SIMTA Intermodal Terminal Project – Stage 1

Peer Review of the Environmental Impact Statement

Project Number: 8201511201-01/Report 001 Ver 2

Prepared for
Liverpool City Council

FIGURE 2-2

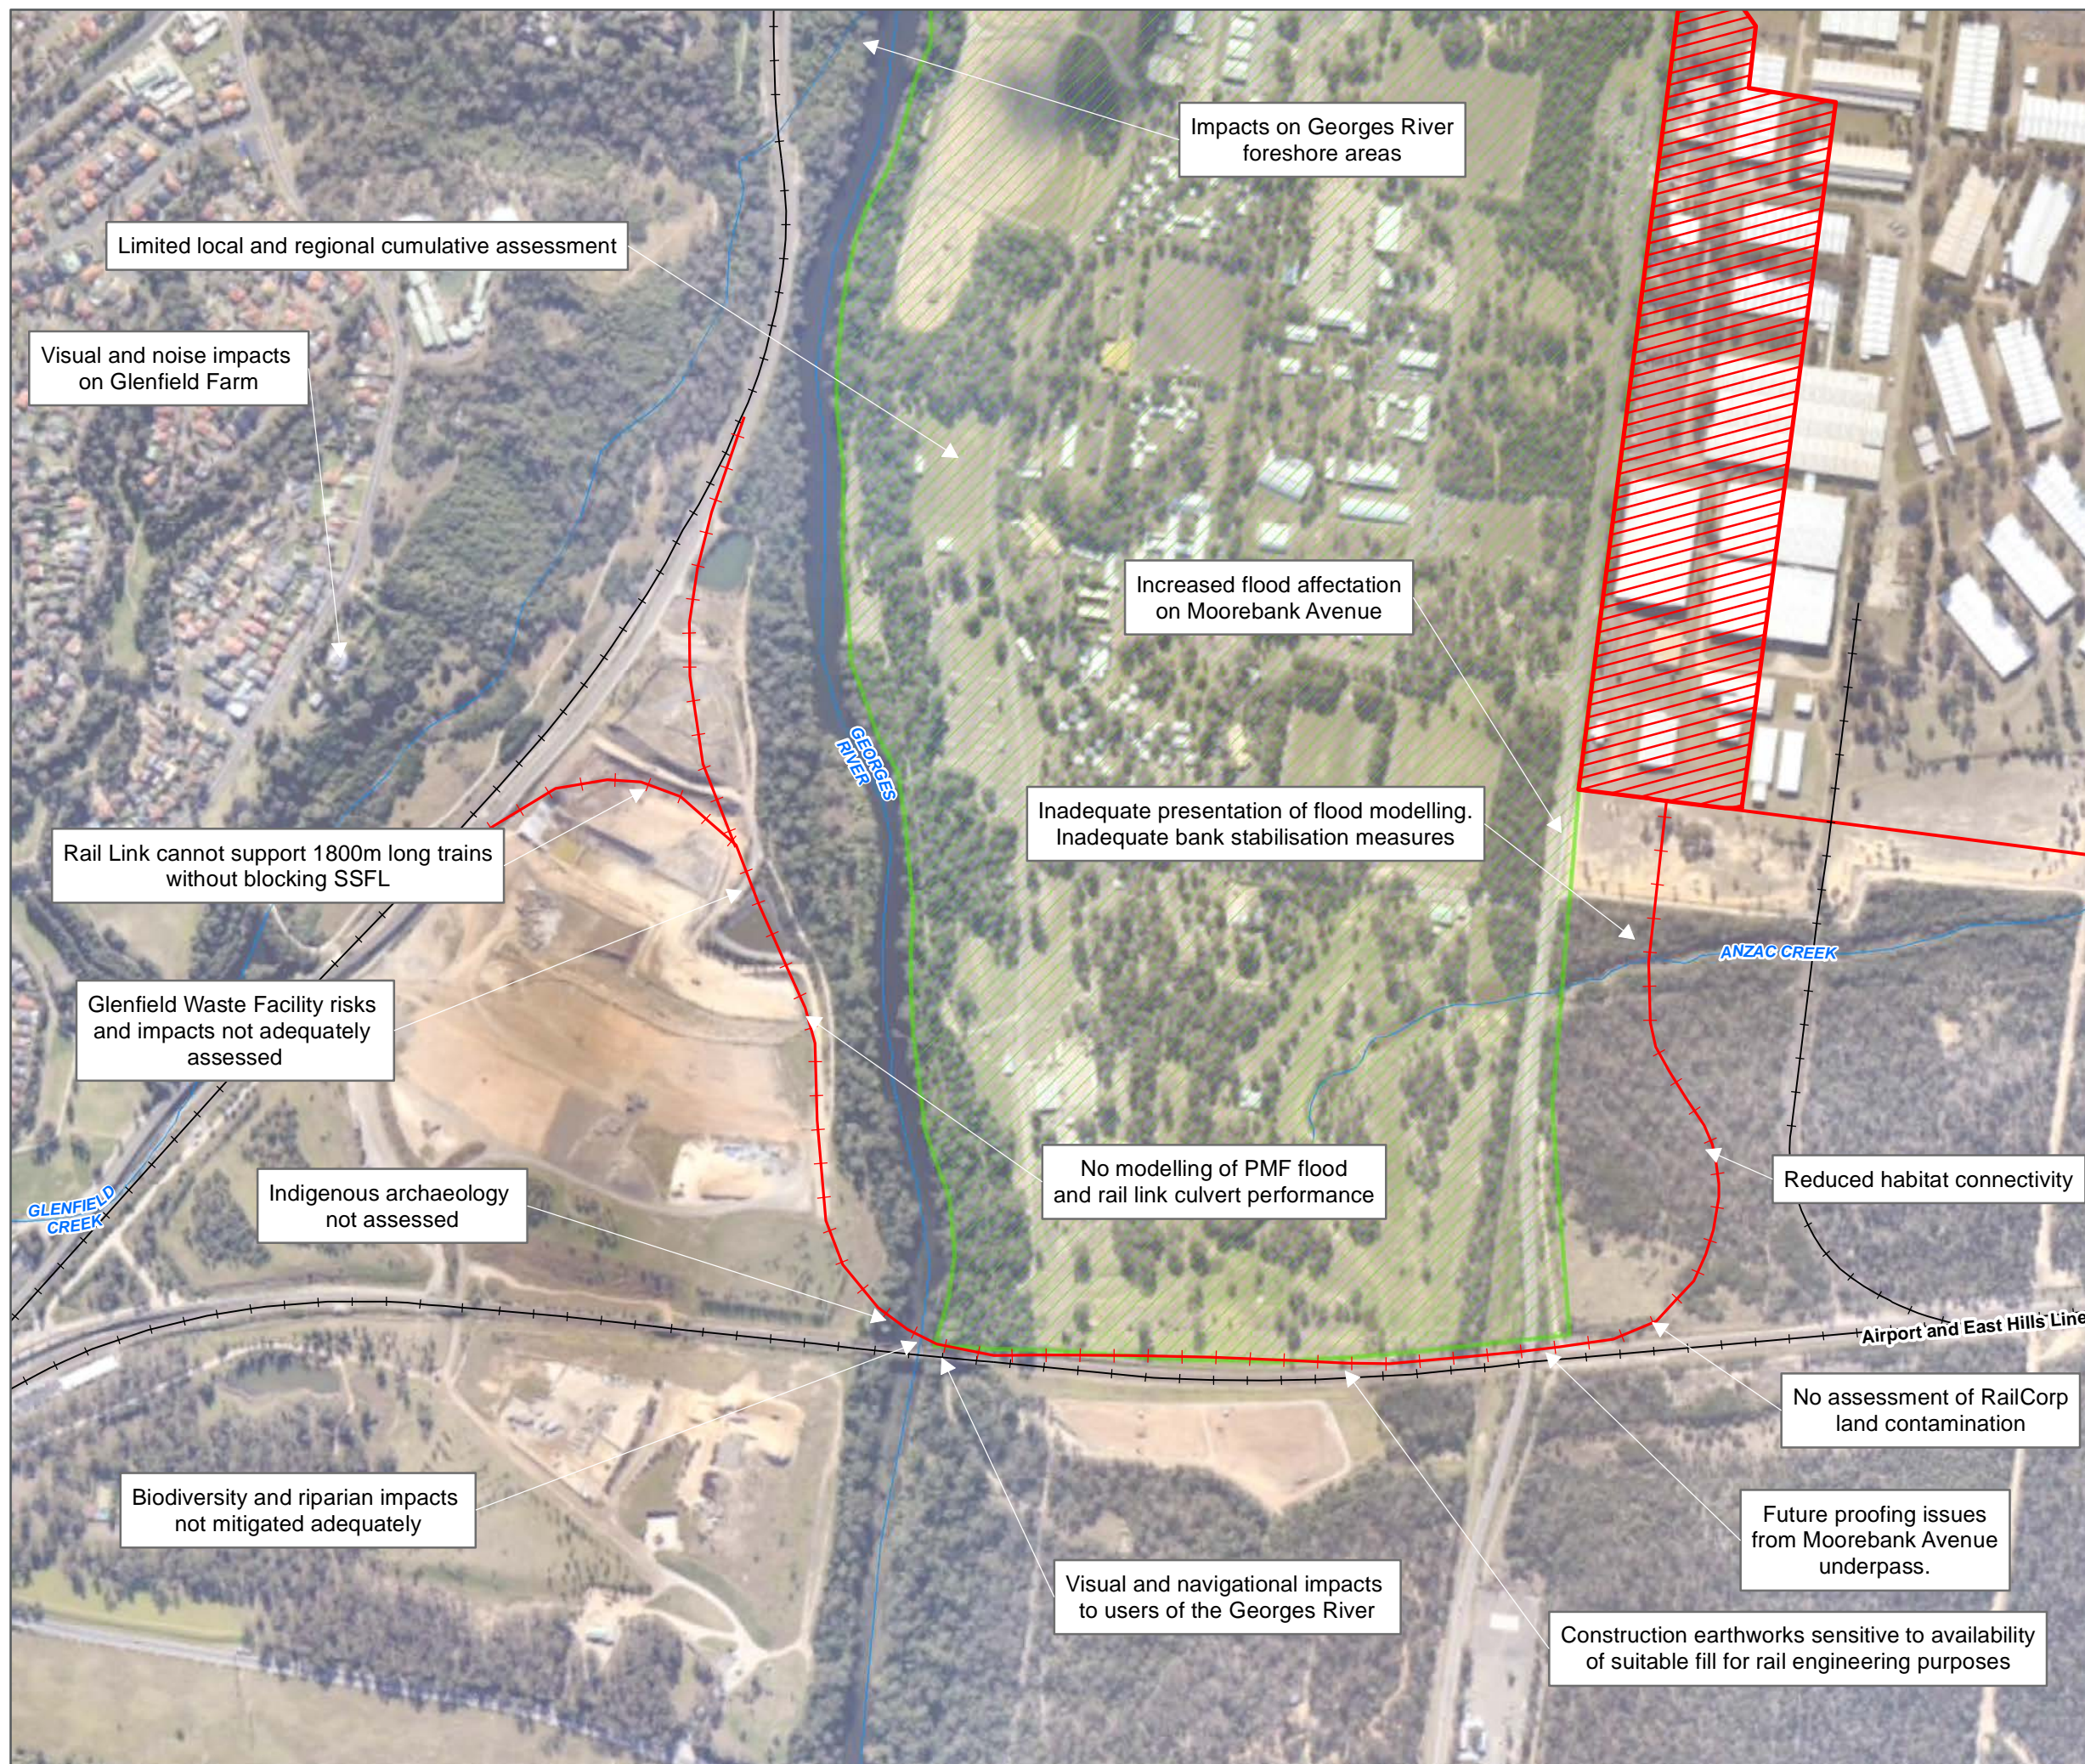
- > Rail operation – the application has relied on assumptions from the Concept Plan (2013) regarding the IMT trip generation. It was assumed that there will be five trips to Port Botany and five trips from Port Botany spread evenly throughout the day. However, in reality this spread will be contingent on a number of external factors which have not been considered. Additional empirical evidence regarding the capacity of the SSFL is required to confirm the operational environment of the IMT, with negotiation and support from ARTC.

- > Land acquisition – a number of land parcels will require acquisition to facilitate the construction of the rail link. There has been no evidence presented in the application to provide certainty around the acquisition policy of SIMTA and the willingness of the landholder to allow SIMTA to construct and operate the rail link.

- > Construction impacts – inadequate information has been provided regarding the construction of the rail link and the volume of imported fill needed for the rail embankment. Construction of the rail link is likely to disturb an area greater than proposed cleared corridor, which will require additional information regarding re-vegetation, soil and water management and soil stabilisation to be provided. Furthermore, the Vegetation Management Plan (VMP) requires a limited level of information that would not result in protection of riparian vegetation and water quality of the Georges River during construction. The bulk earthworks strategy does not consider the required volume of imported fill needed for the rail embankment. The cost of importing this large amount of fill will be substantial which needs to be confirmed prior to the finalisation of the bulk earthworks strategy.

- > Visual impacts – limited assessment of the visual impact of the rail link along the western bank of the Georges River has been provided. The provision of the rail link along this alignment will fundamentally alter the vista from the Glenfield Farm heritage item, as well as the visual character of the Georges River for recreational users, with recreational use predicted to increase due to the planned upgrade of the Georges River Casula Parklands Precinct.

The POEO Act regulates ongoing activities with the potential to cause environmental damage and harm. Activities that meet defined criteria may be subject to licensing and ongoing monitoring by the EPA. Schedule 1 of the Act identifies activities which are subject regulation.

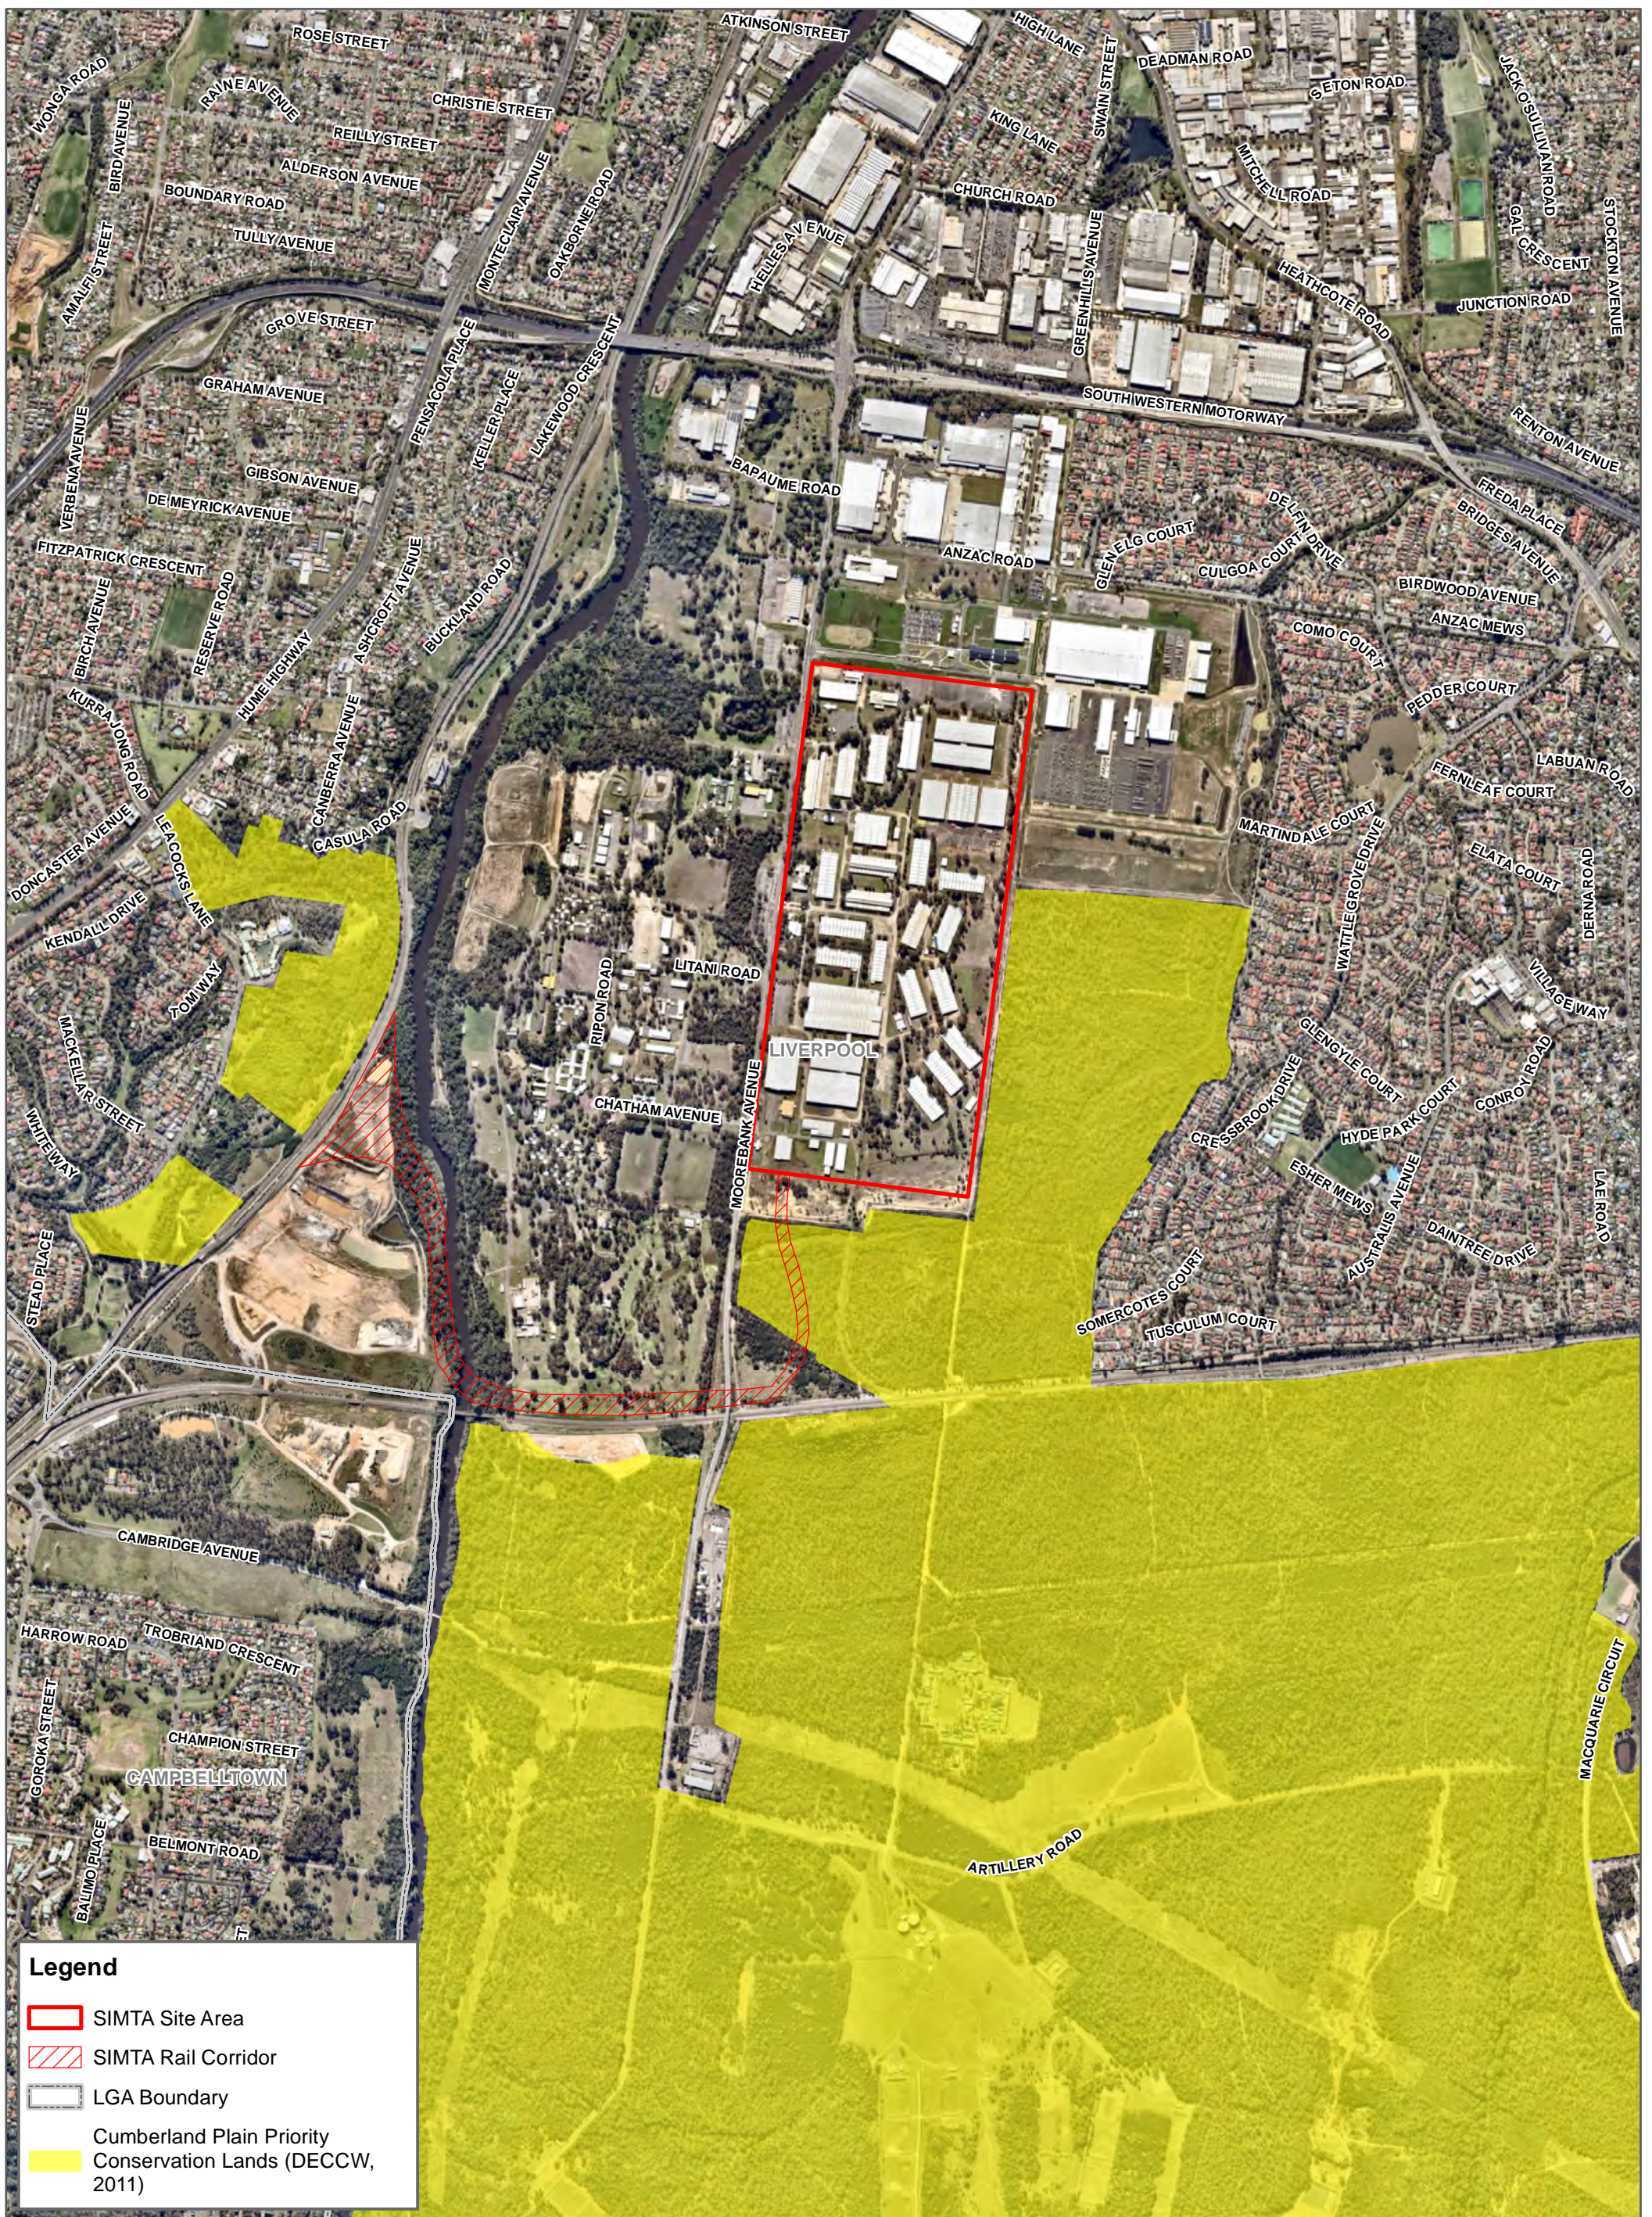
The Boot Land is located within the Cumberland Plain Priority Conservation Lands as identified in **Figure 4-1**. The Assessment report identified that in addition to resulting in the loss of habitat within the PCL “*The Rail link would potentially be fenced and therefore would create an additional barrier to connectivity between the remaining patch of bushland west of the Rail link and remnant bushland within the Boot Land.*”

The potential for erosion to occur in the riparian zone is highly likely due to the extent of construction activities. Stabilising the soil in the construction zones of the riparian corridor will therefore be essential. The VMP currently has no detail on the measures required for soil stabilisation.

A comprehensive photographic record of the site should be undertaken (or be recommended to be part of the proposed VMP works) to assist with the reporting and monitoring requirements of the VMP. A cost estimate needs to be prepared for the VMP. The current VMP would be impossible to cost due to the lack of detail, vague language used and un-measurable outcomes. All proposed works need to be clearly defined and quantified.

Figure 4-3 Proposed MIC Site Layout

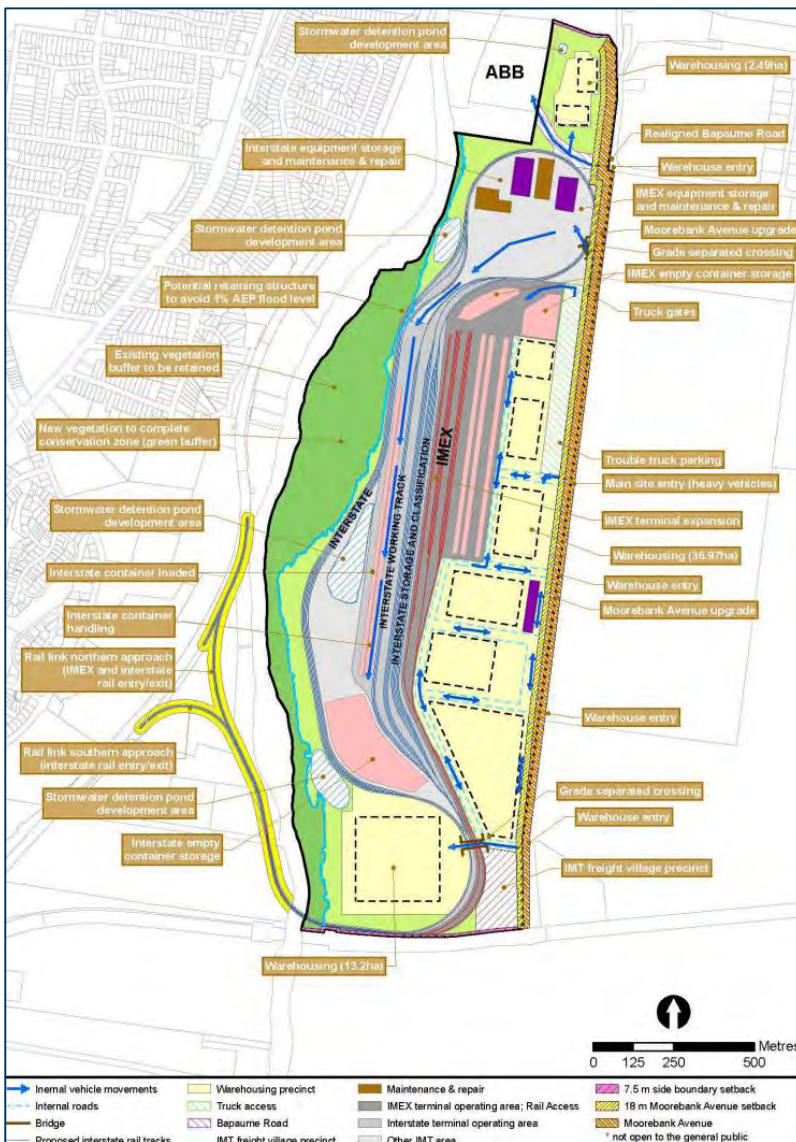
Cardno has reviewed the publically available information associated with the MIC proposal and has determined that the maximum height proposed is 21 m. The MIC proposal also noted the indicative locations of the main buildings and structures on site (refer to **0**).

Figure 4-5 Location of Receivers with Viewpoint to Rail Link

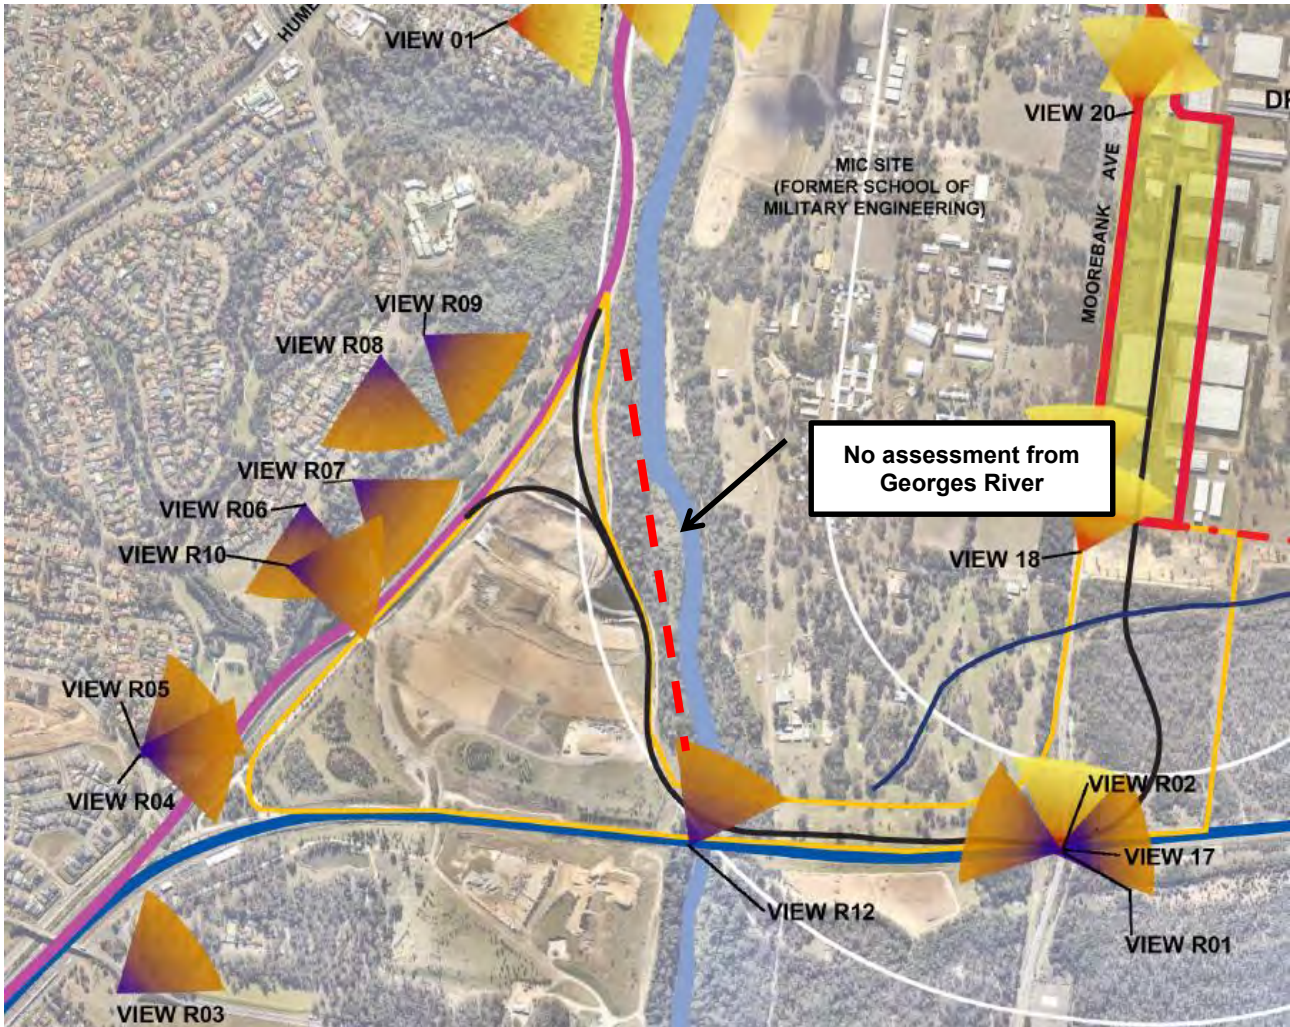
The visual impact assessment has not considered the visual impacts from the proposed rail link / rail corridor to a sufficient standard. The assessment has identified a number of sensitive receivers surrounding the rail link, however this has not considered users of the Georges River (refer to **Figure 4-5**).
